January 15, 2026

CONTRACT NO. 1797

OHIO RIVER TUNNEL

ADDENDUM No. 12

A48-ST-306
ORT-A48-RG PLANS
SHEET 1 OF 2

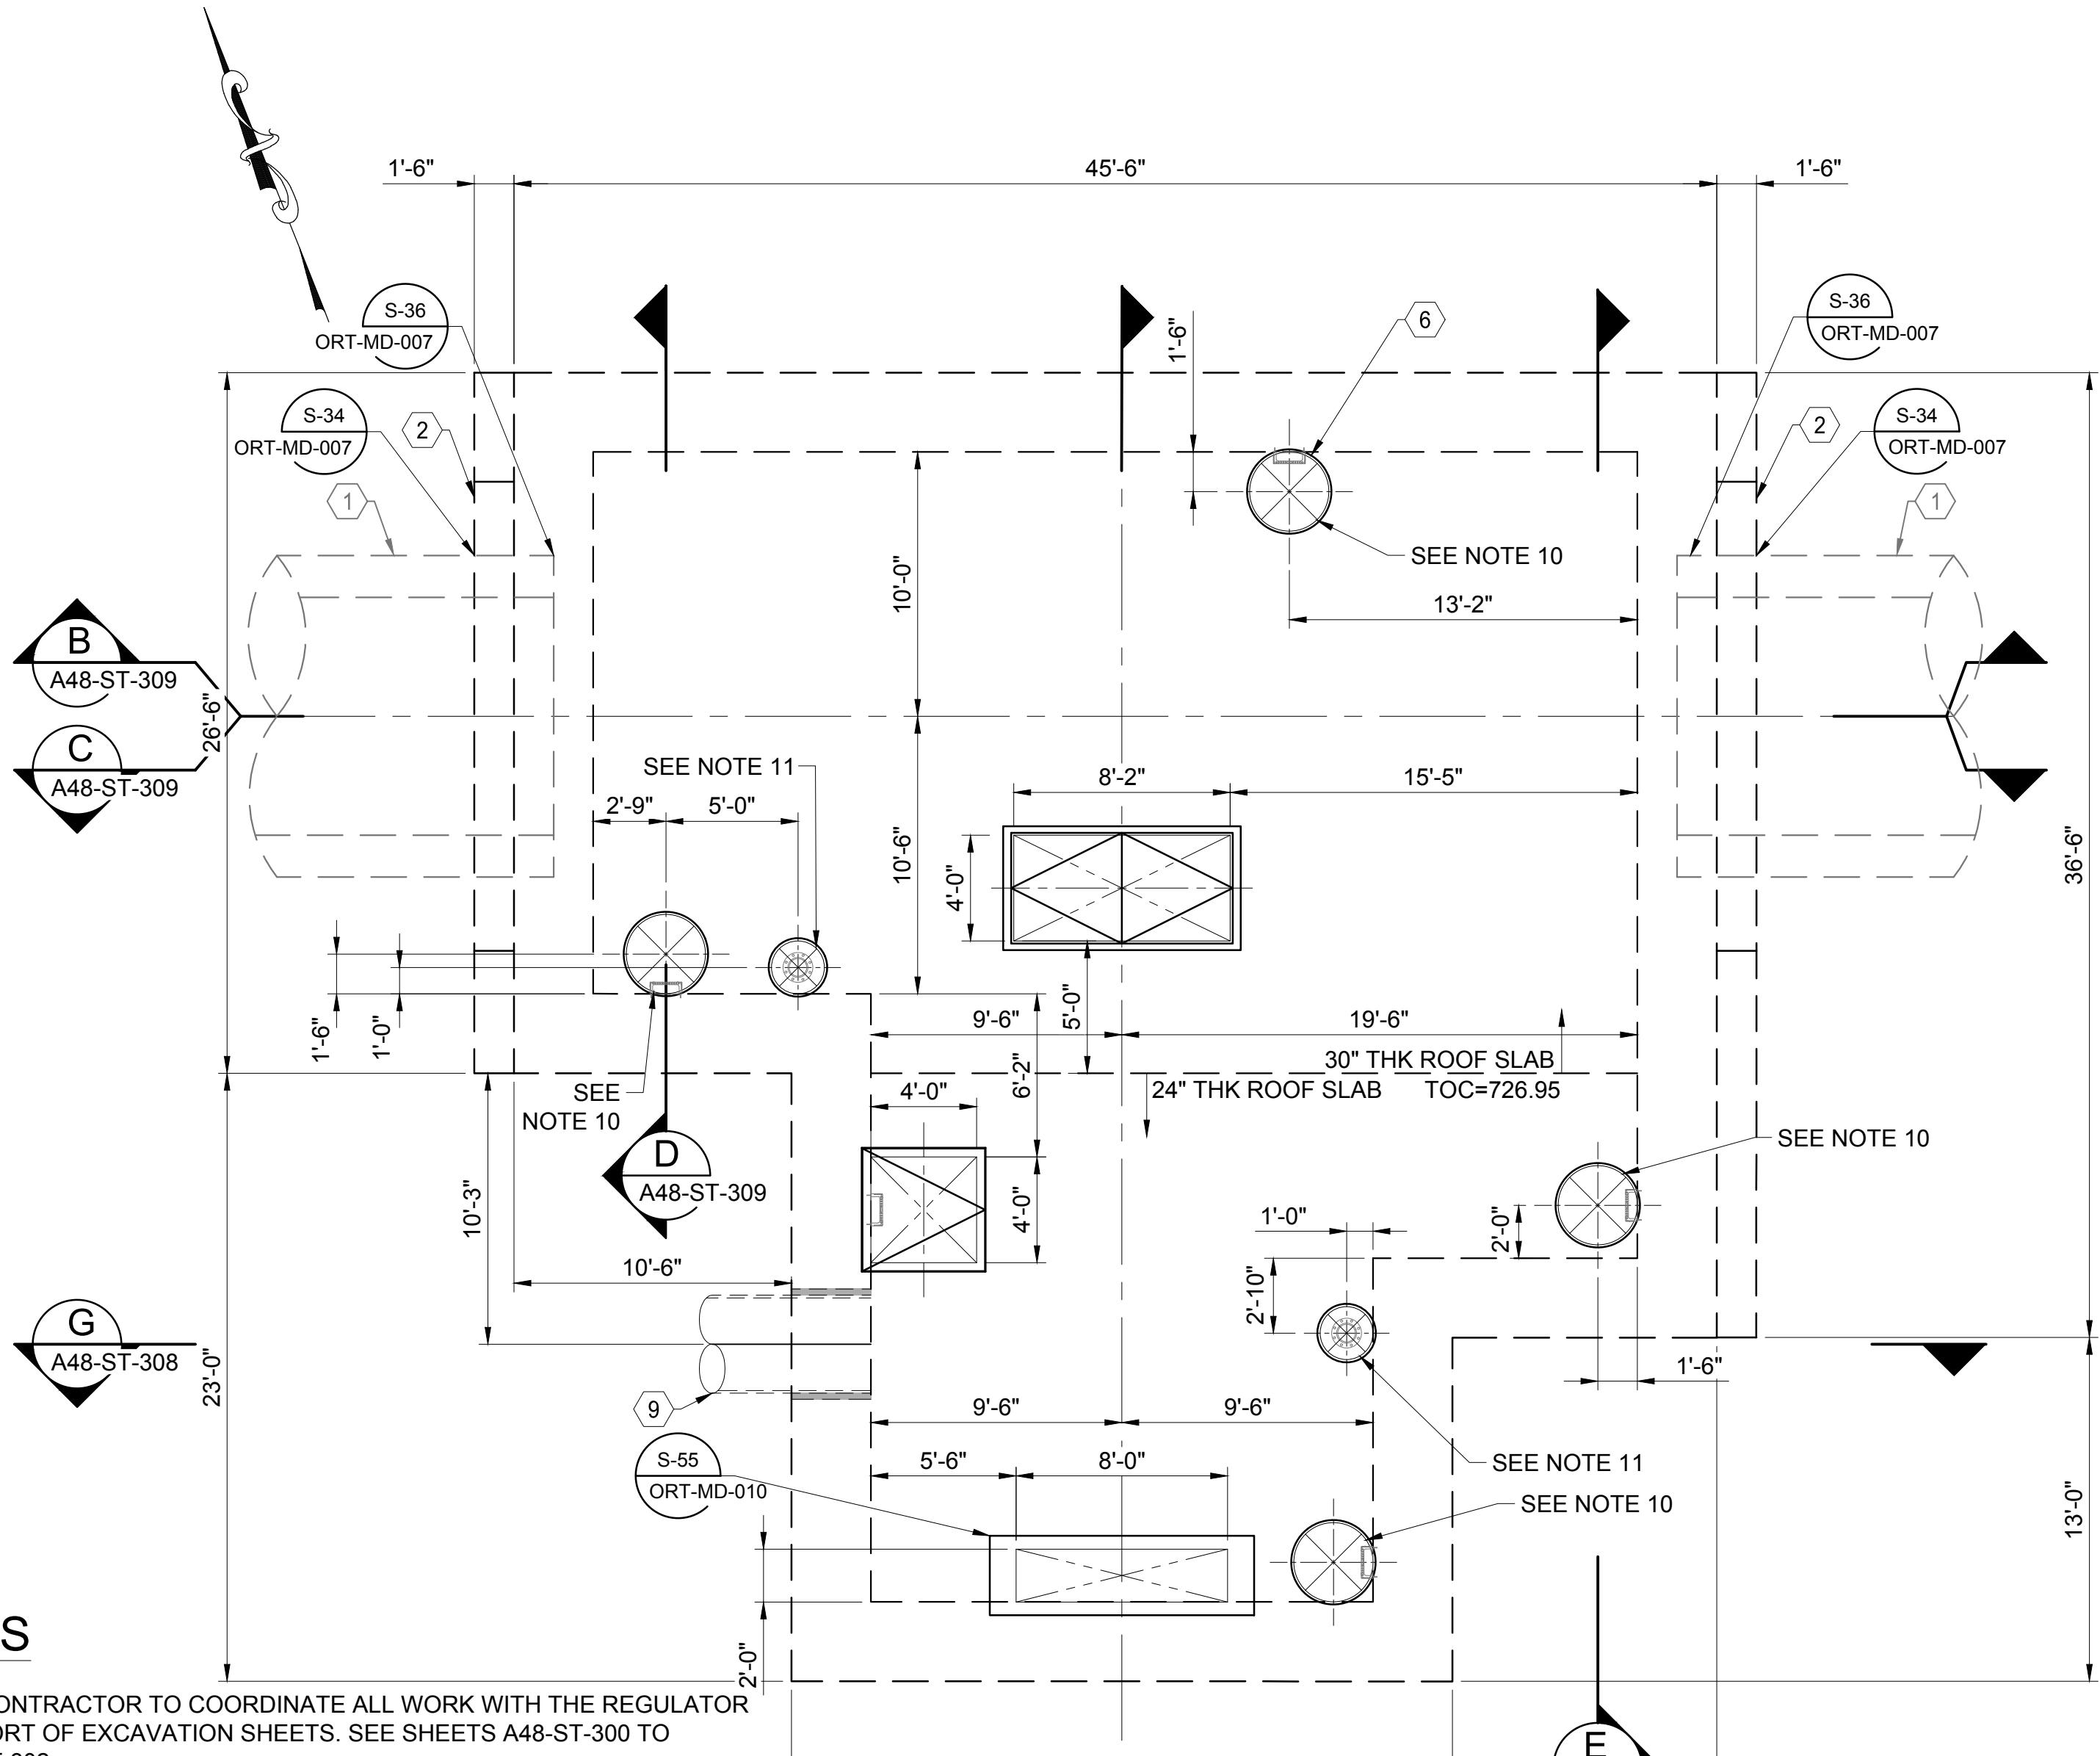
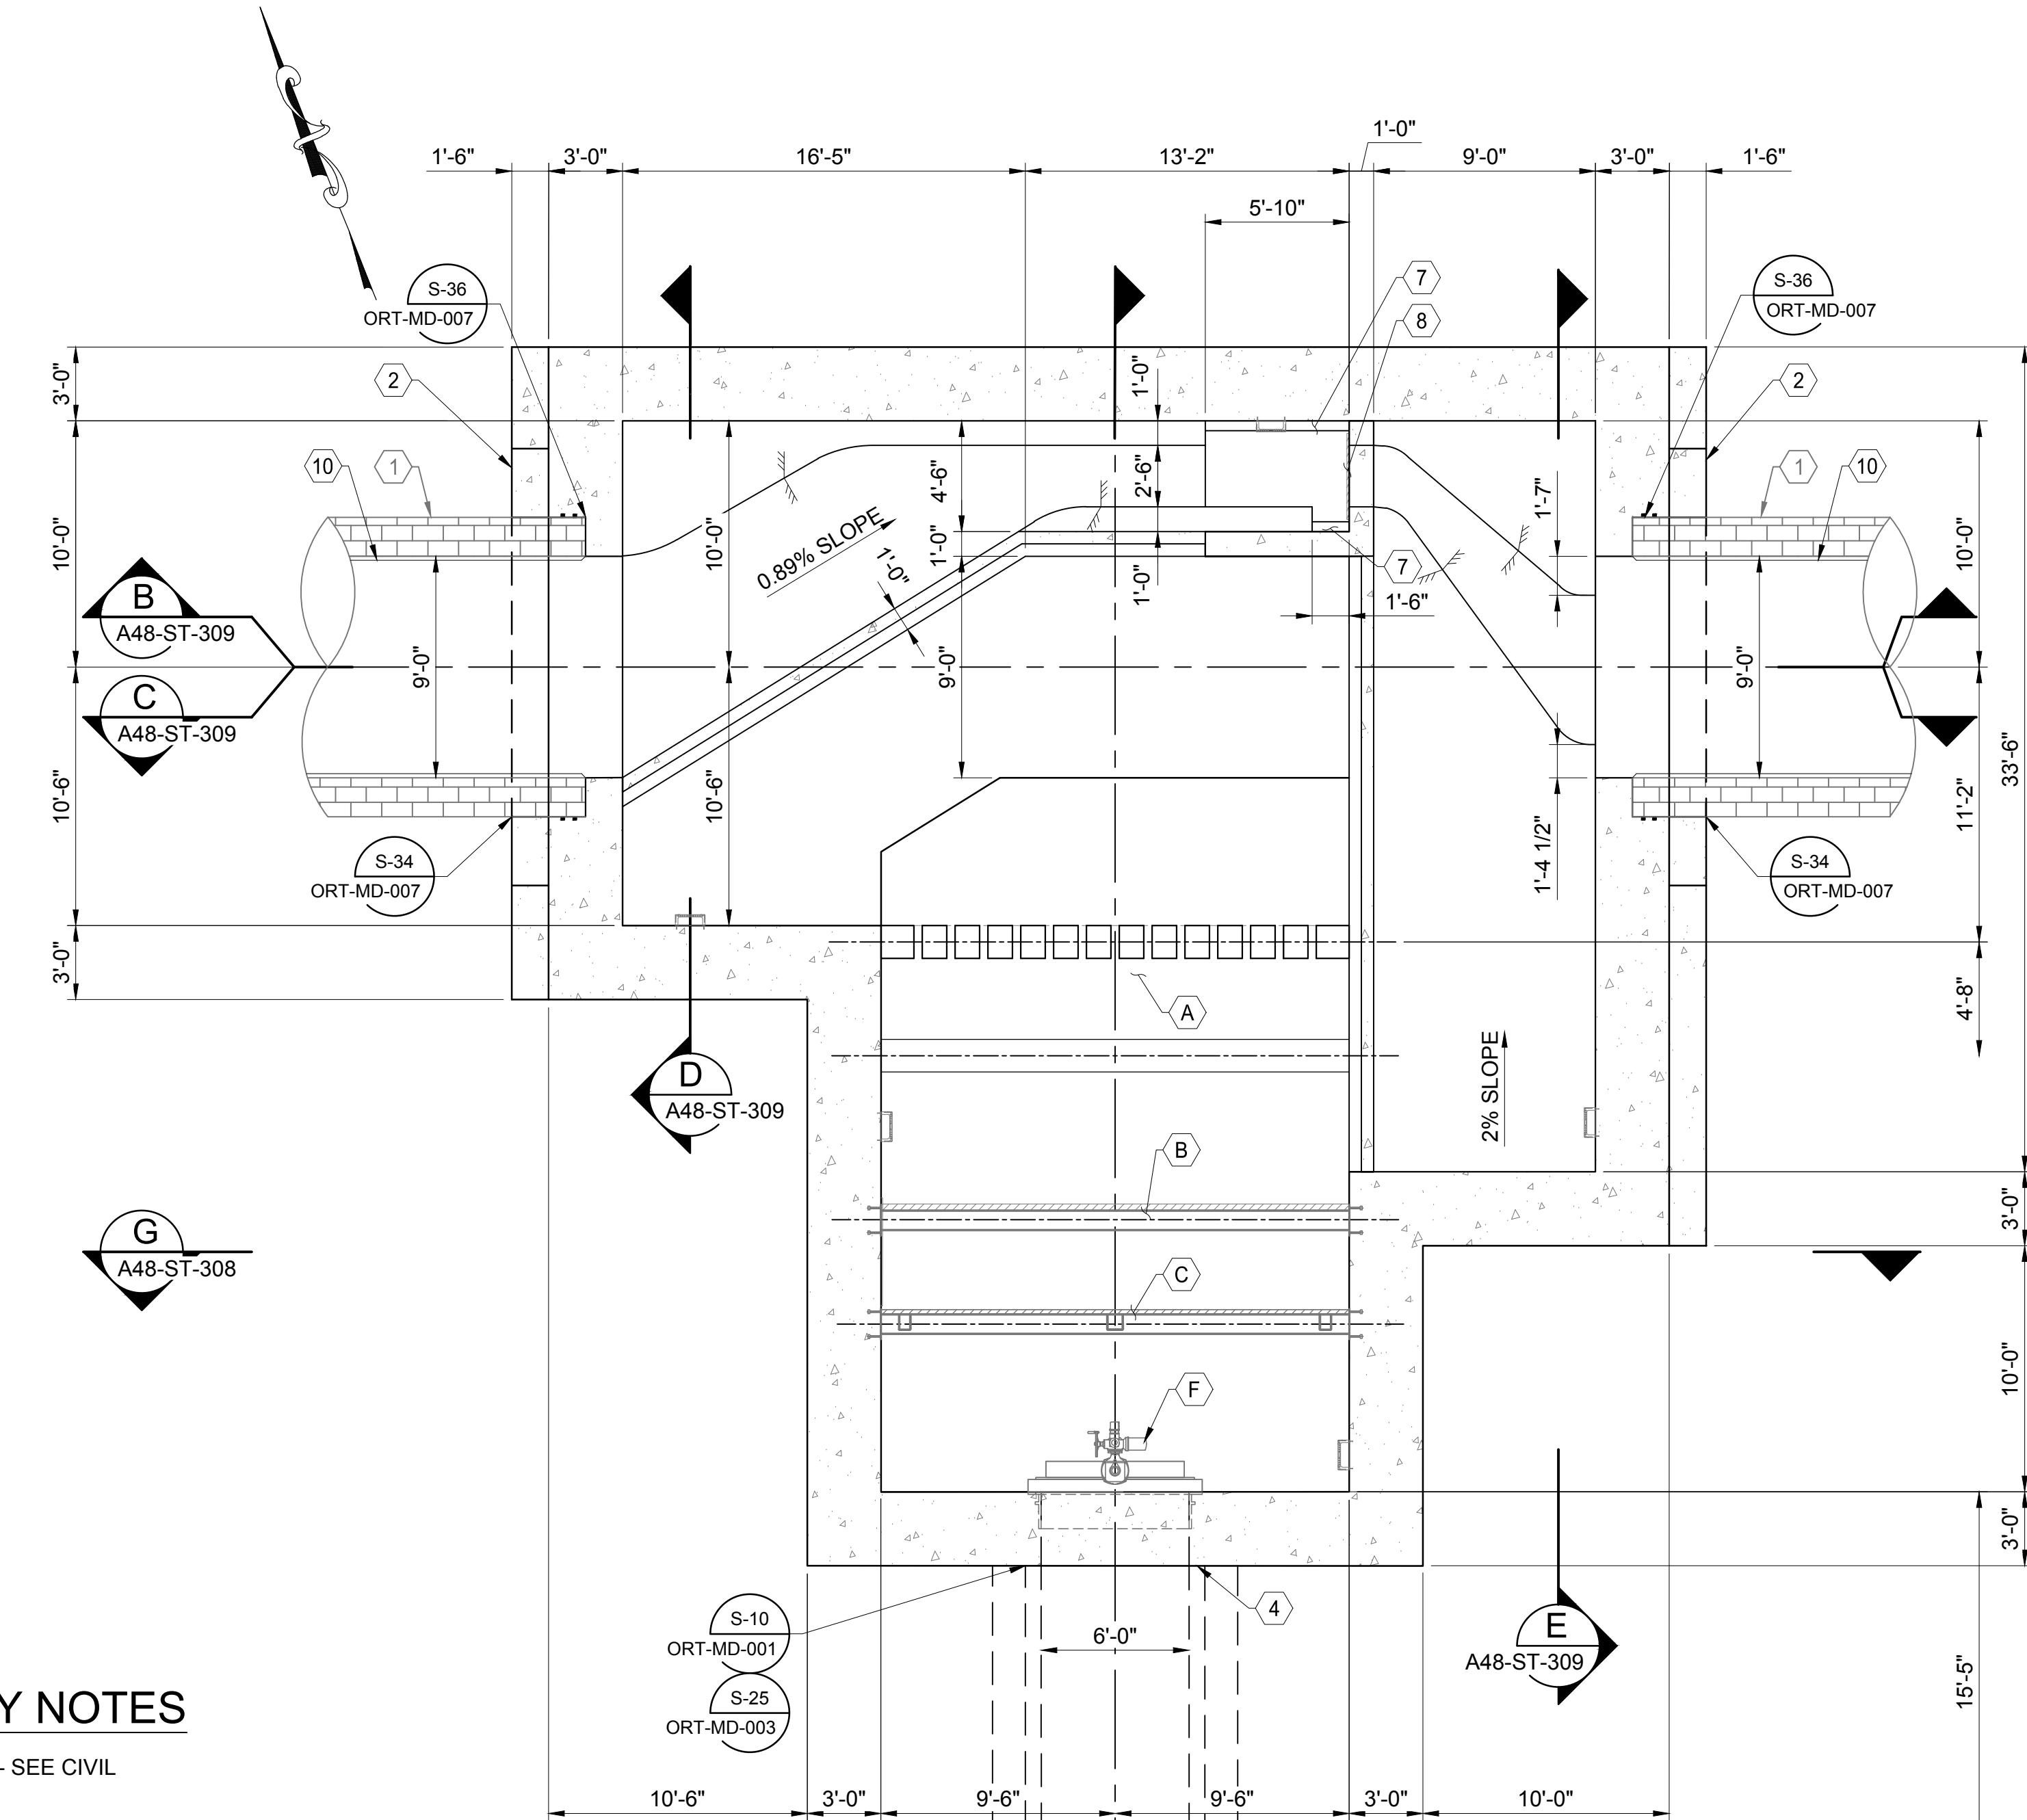
- b. DELETE A48-ST-306 (Sheet 367 of 770) and ADD revised A48-ST-306 (Sheet 367 of 770), which is Attachment C of this Addendum.
 - c. DELETE A58-ST-424 (Sheet 425 of 770) and ADD revised A58-ST-424 (Sheet 425 of 770), which is Attachment C of this Addendum.

A13 **CIPP has been revised to shotcrete (or gunite). Note that full description of shotcrete application, including thickness and extent (across the entire connection zone) in all existing sewers are given in the respective SOE series of drawings per site.**
See Section B, Item 6 and Attachment C of this Addendum for CHANGES TO CONTRACT DOCUMENTS including Contract Drawings O27-ST-122, A48-ST-306, A58-ST-424, and O06A-ST-806.

- ① EXIST 108" ID BRICK SEWER - SEE CIVIL SHEETS (NOTE 4)
- ② CONCRETE COLLAR
- ③ 72" ID RCP - SEE CIVIL SHEETS (NOTE 4)
- ④ ISOLATION WATERTIGHT JOINT (TYP.)
- ⑤ ORT-A48-DS - SEE DROP SHAFT SHEETS
- ⑥ ACCESS COVER (TYP.)
- ⑦ 0.4' x 0.4' CHAMFER
- ⑧ SS ORIFICE PLATE - SEE SHEET ORT-MD-040
- ⑨ 42" ID DI RG VENT PIPE, SEE CIVIL SHEETS
- ⑩ 2" THICK SHOTCRETE (SEE A48-ST-300 FOR REQUIREMENTS)
